Product Change Notice (PCN)

PCN Number: PCN-0451188R-01

Product(s) Affected: *PJ-051A, PJ-051B, PJ-051AH, PJ-051BH*

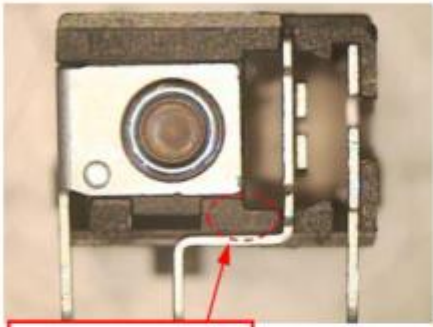
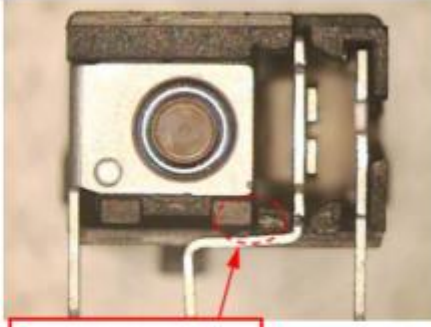
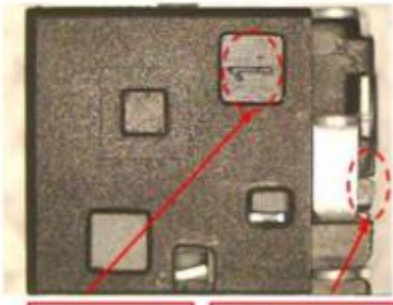
Reason(s) for Change: *The existing molds of PJ-051A, PJ-051B, PJ-051AH, and PJ-051BH are unable to maintain efficient production. To ensure the quality and lead-time of production, a re-development of the mold has been processed. We have taken this opportunity to also optimize the product design to enhance the quality. The new mold will optimize the design, enhance the appearance, the electrical structure while function will remain the same (The comparison photos are available below).*

Description of Change: *Photos of changes included below.*

New version	Current version
Back	 <p>Without gap</p>	 <p>With gap</p>
Bottom	 <p>Smaller mark Without gap</p>	 <p>Bigger mark With gap</p>
